Technical Memorandum

To:	Ground-Level Monitoring Committee, Chino Basin Watermaster
From:	Wildermuth Environmental, Inc. (WEI)
Date:	December 13, 2017
Subject:	Task 3 and Task 4 of the Work Plan to Develop a Subsidence Management Plan for the Northwest MZ-1 Area: <i>Development and Evaluation of Baseline and Initial Subsidence-Management Alternatives</i>

Response to GLMC Comments

Figure 6

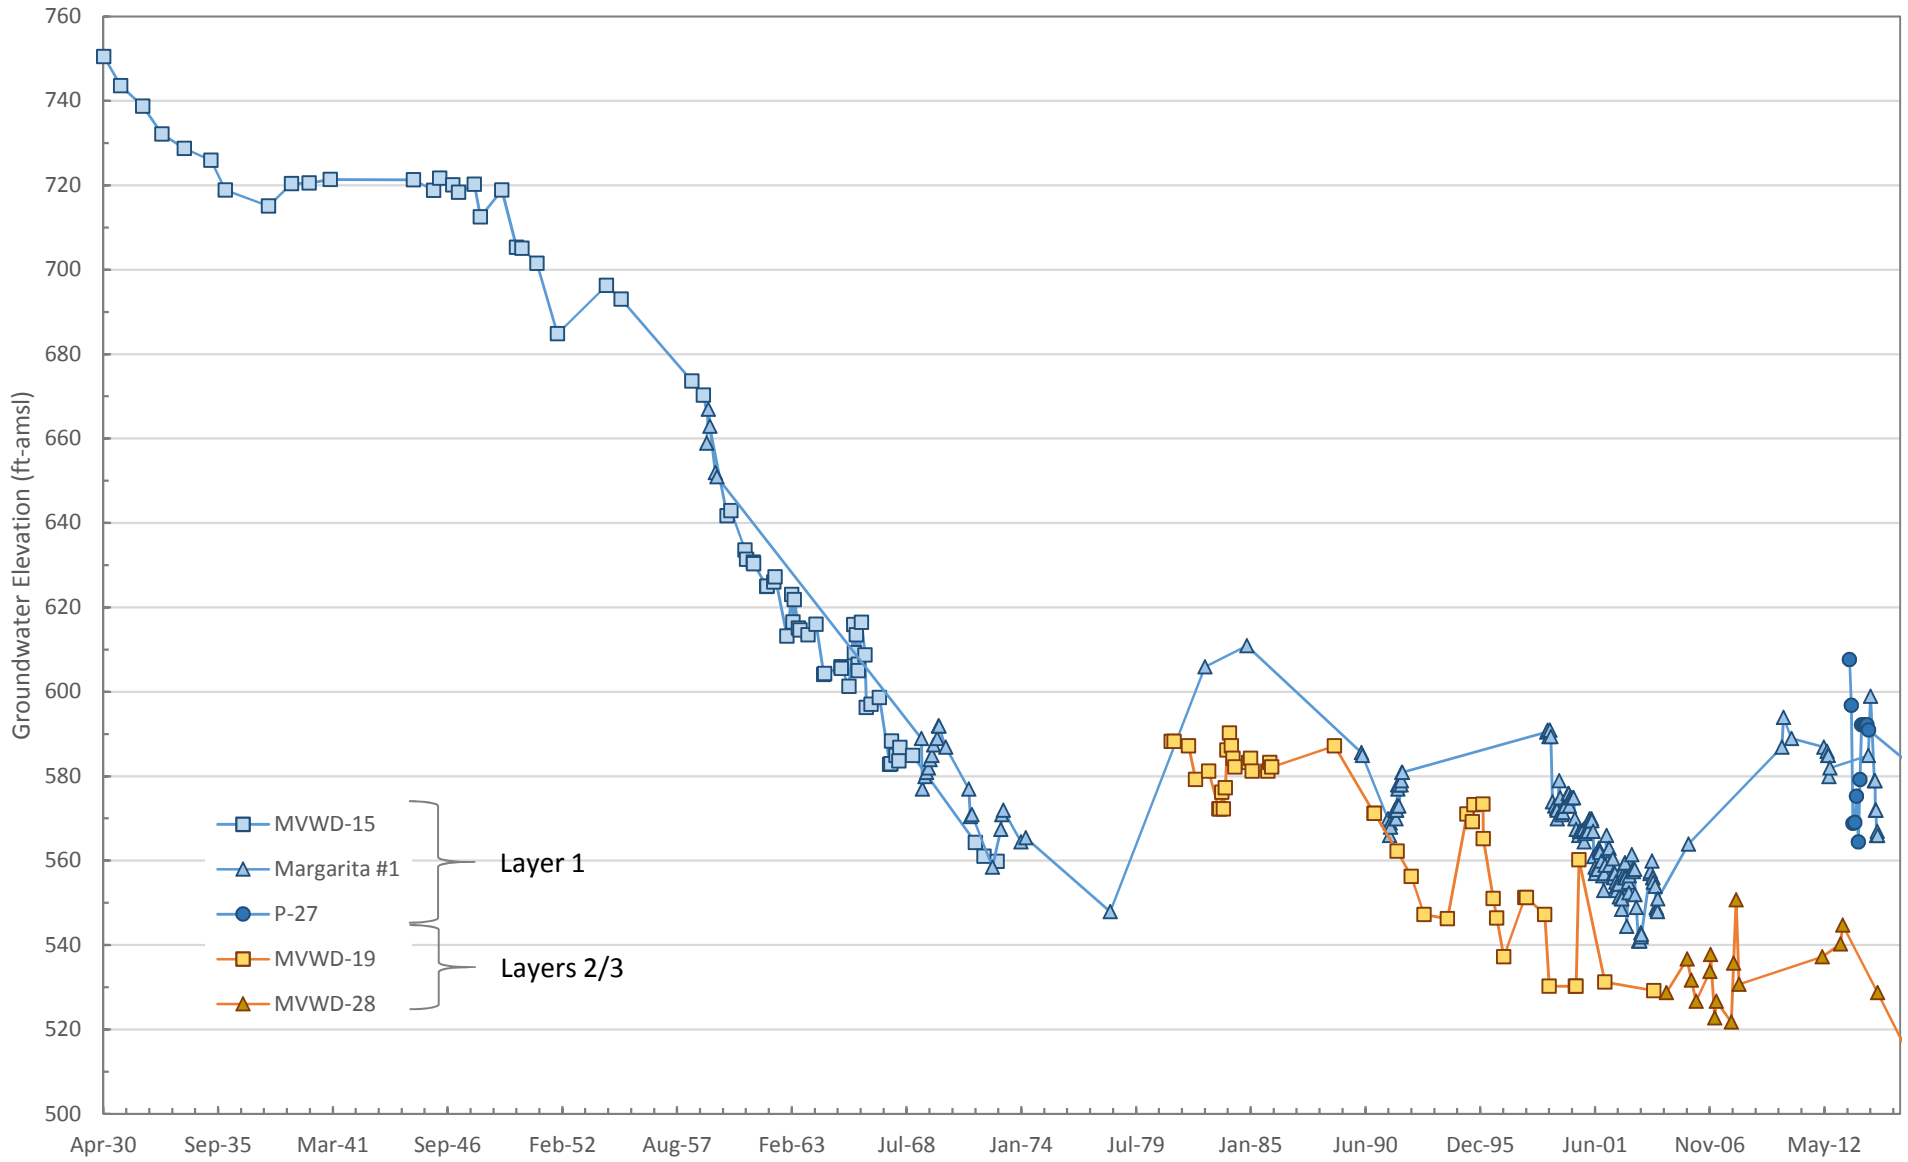
Comment 3, P. 10, second paragraph, second sentence:

The model is used to simulate deformation extending back to 1930, so if this zone was saturated during this early period it may result in some inaccuracies of the early simulations of deformation. The zone appears to consist primarily of coarse-grained material so if a portion was saturated in the 1930’s and subsequently drained there was probably negligible deformation. Suggest including the elevation of the base of the 280-foot depth interval so the reader can compare this number to the simulated groundwater elevations in Figure 6.

The 280-foot depth interval is never saturated during the simulations. The elevation of the base of the 280-foot depth interval is 773 ft-amsl, which is above the initial condition for head in 1930 and is above the highest head shown on Figure 6. The 280-foot depth interval was a conservative choice made to preserve flexibility for potential future simulations.

Figure 7
Model-Simulated Aquifer-System Deformation versus InSAR-Estimated Ground Motion
at the MVWD-28 Well Location for Final Calibration of the 1D Model

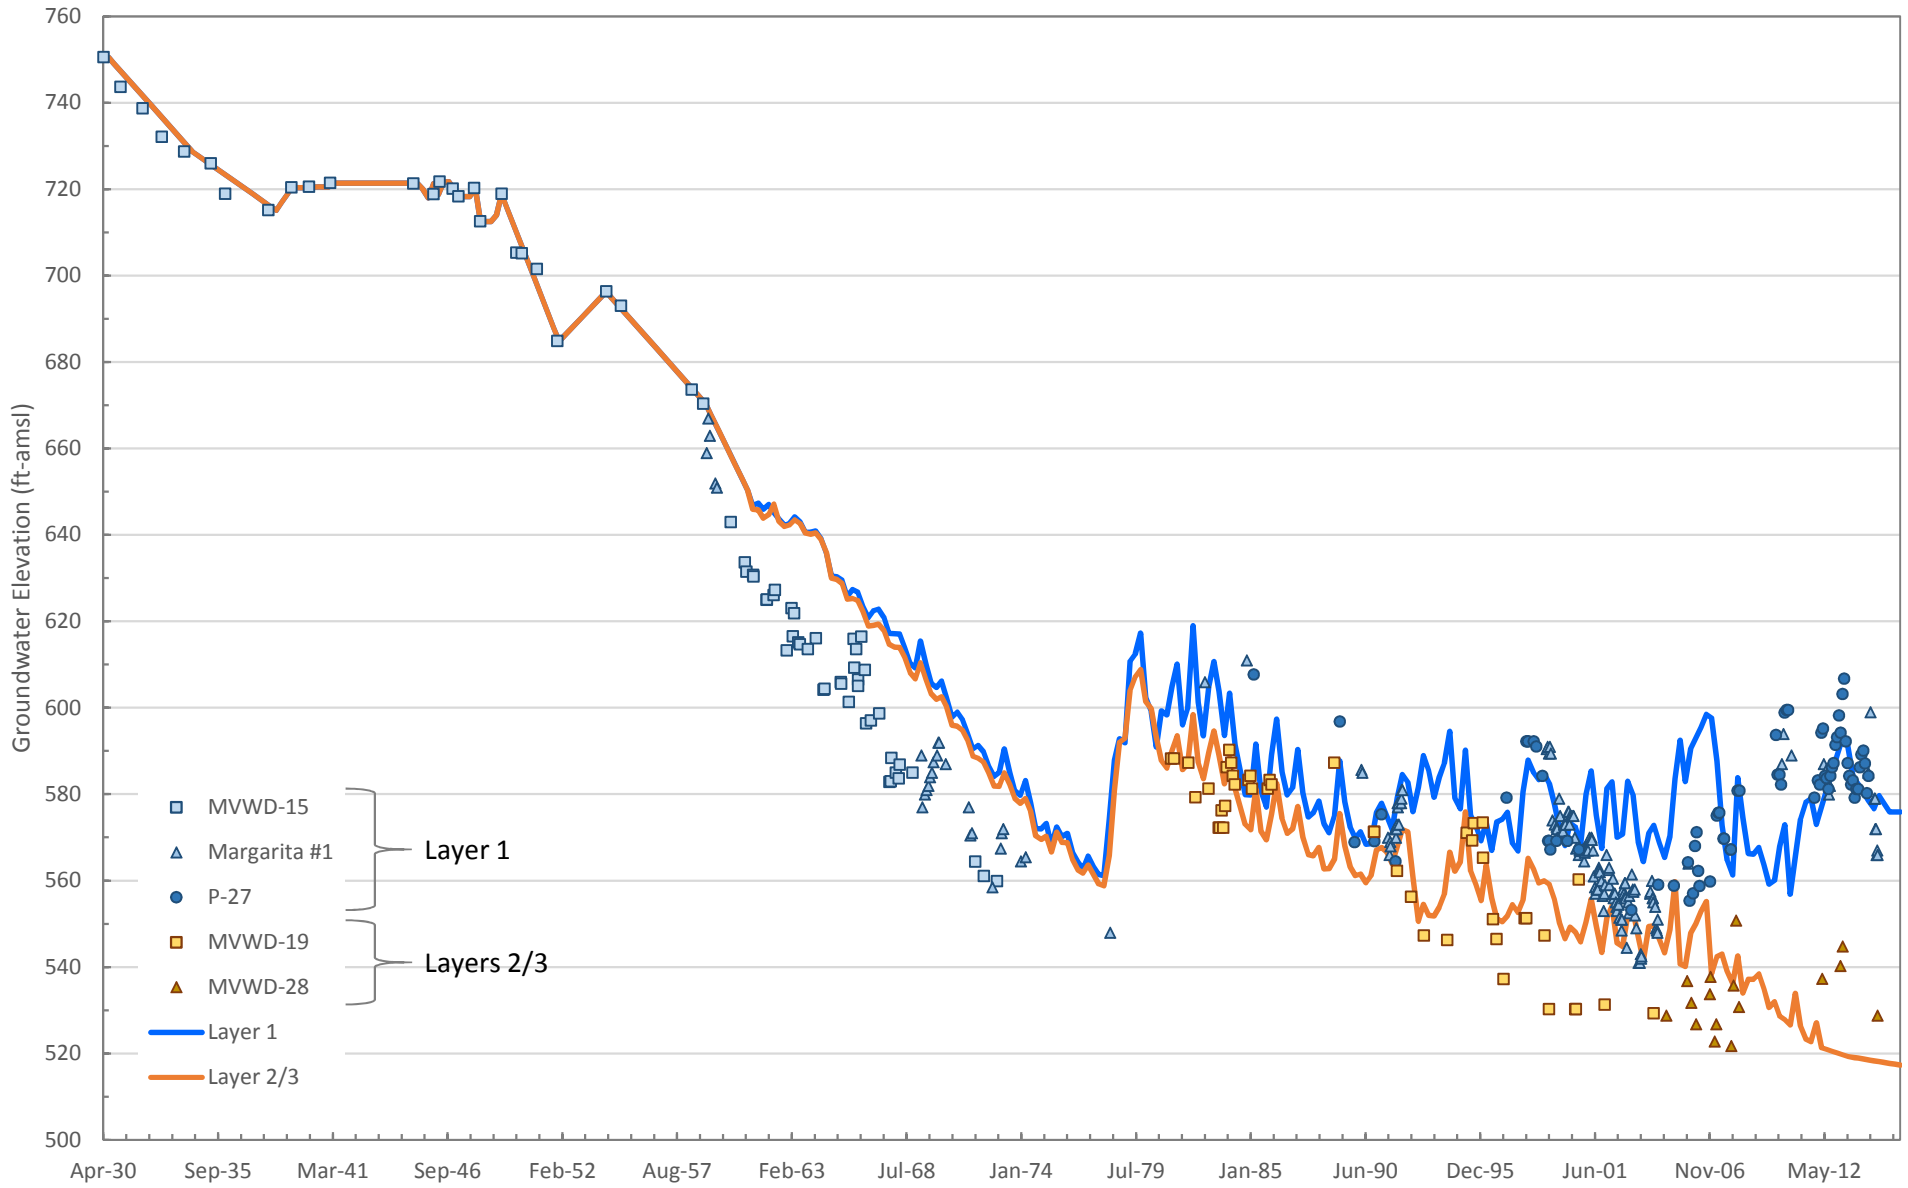
Despite the stabilization in water level trends over the last 20 to 35 years, In-SAR data shows continued subsidence through the model calibration period (WEI Figure 7, Figure 3 attached). This indicates that the subsidence occurring in the Chino Basin is delayed in its response to declining groundwater levels during the period from 1930 through 1978. This delayed subsidence was recognized on page 2 of the technical memorandum, which states that “from about 1930 to 1978, heads in Northwest MZ-1 declined by about 175 feet. Since then, heads have recovered, but have remained below the levels of 1930. The observed and continuous subsidence that occurred between the 1992 to 2016 period cannot be explained entirely by the concurrent changes in head. A plausible explanation for the subsidence is that thick, slow-draining aquitards are compacting in response to the historical head declines that occurred from 1930 (or before 1930) to 1978.” Considering the great thickness of the aquitards and the observed time lag between the recovery of groundwater levels and the ongoing occurrence of land subsidence in the study area, simulating subsidence using the 1-D Model is not suitable for this area.

Figure 9
1D Model Simulated Compaction at the MVWD-28 Well Location
1930-2015

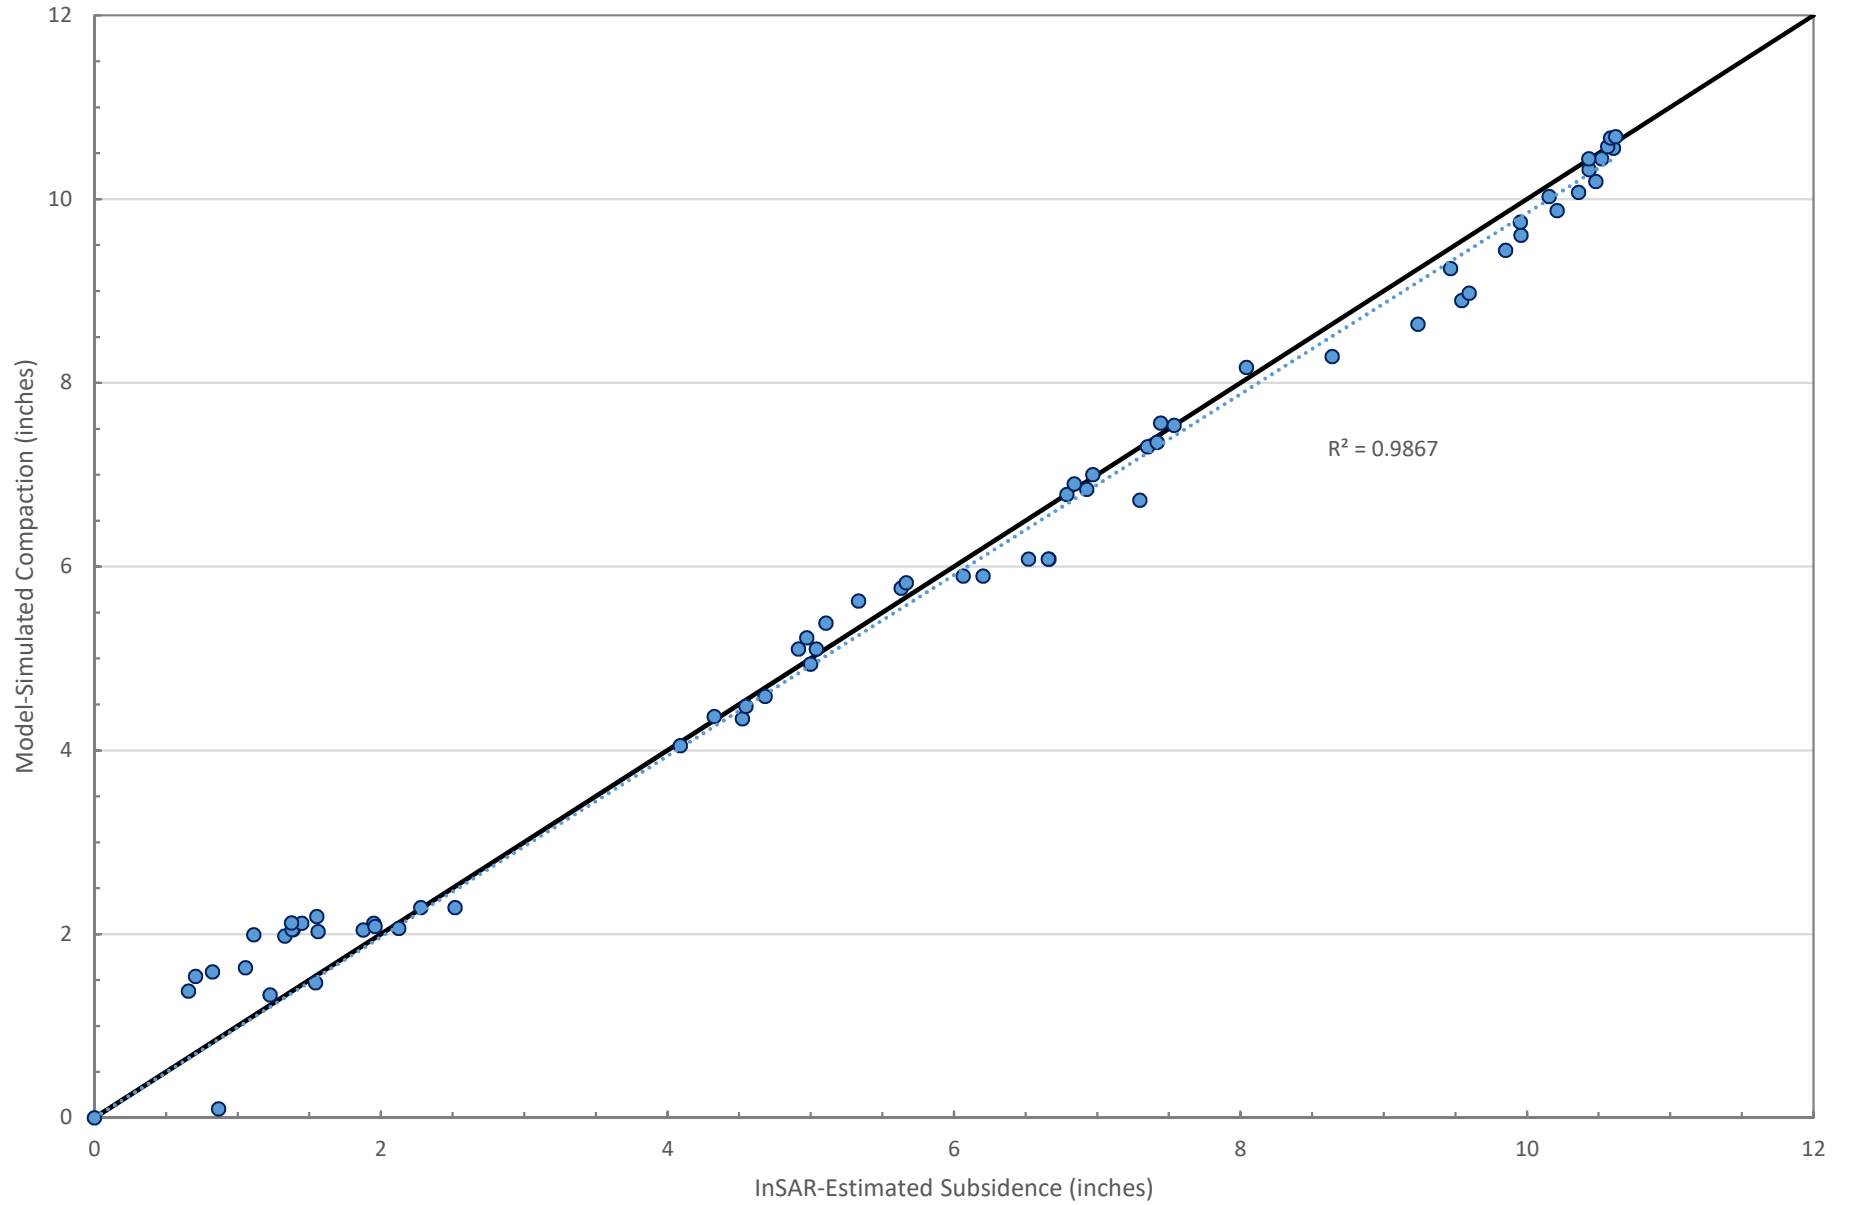
Comment 10, Under Results and Interpretations, 1-Dimensional Aquifer-System Compaction Model, Historical Subsidence Simulation, Figure 9:

On Figure 9, it would be helpful to better understand the model response to ongoing residual compaction if the modeled groundwater level and pre-consolidation hydraulic head for the layers was presented along with the simulated compaction. That is, has the rate of compaction leveled off since the mid-1970s because groundwater levels have recovered above an established pre-consolidation hydraulic head level?

Yes. Inspection of Figure 2 shows that water levels at many wells in Northwest MZ-1 declined to an all-time low by 1977, and then recovered by about 100 feet over the next 8-10 years. This is the reason for the break in slope in the model-simulated compaction curve at about 1978 on Figure 9.
